# ASSESSMENT REPORT

## **DEVELOPMENT APPLICATION (2016STH035 DA – DA10.2016.304.1)**

### **PROPOSED MIXED USE DEVELOPMENT – RETAIL & COMMERCIAL PREMISES AND SHOP-TOP HOUSING**

VARIOUS ALLOTMENTS  
TERRALONG, AKUNA AND SHOALHAVEN STREETS, KIAMA

**Figure 2: Building Height Plane for Original Proposal (ADM Architects).**

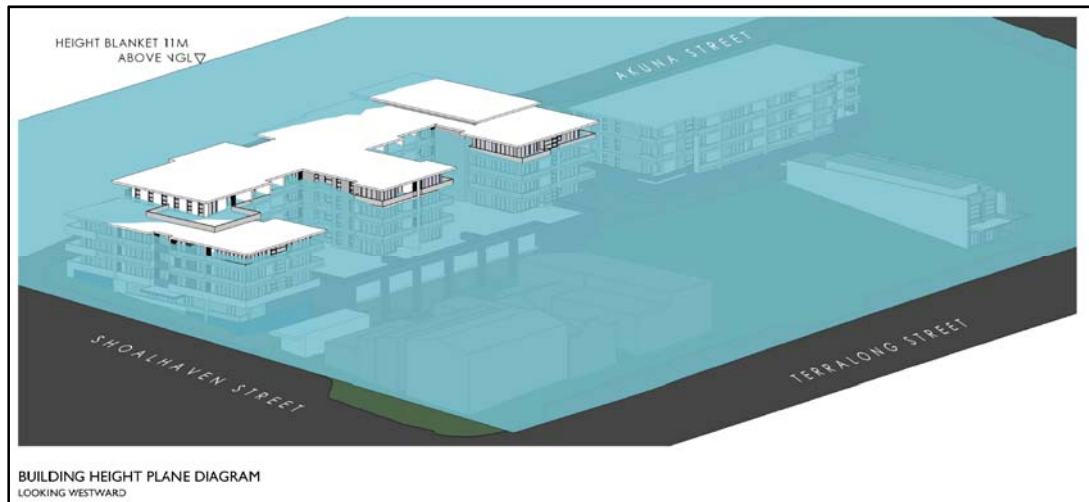
As evident from **Figure 2** whilst Building D & E sat below the 11 metre building height limit, almost the entire upper floor of the remainder of the development encroached above the 11 metres height limit. The Applicant was advised that this encroachment was not supported.

**Figure 6: TPZ relative to site and proposed site layout.**  
(Appendix B – Plan 6; Allied Tree Consultancy, 2017)

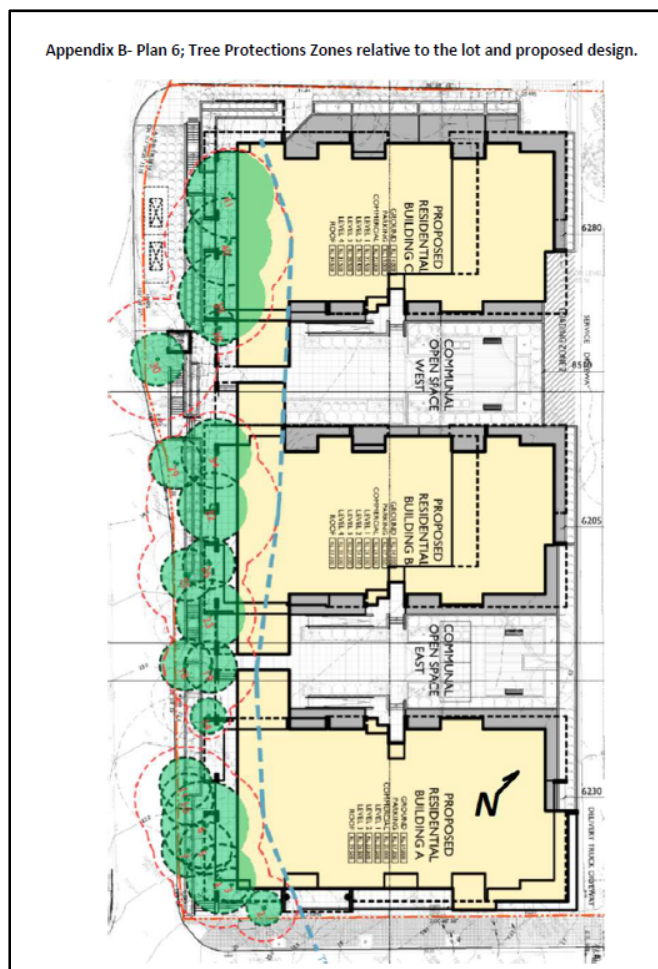
The revised development proposal still seeks to remove these trees. The Applicant's position is spelt out in the revised SEE prepared by TCG Planning which states:

*The extent of possible impact of the design based on the tree retention is demonstrated in Figure 1, which shows the TPZ for each tree with a line joining the perimeters of the larger TPZs. ADM Architects confirm that the area between the building facade and blue line equates to 355m<sup>2</sup> over just one level of the building. If redesign was required to retain the trees the loss of this floor area, when multiplied over a number of levels, would significantly impact on the feasibility of the project.*
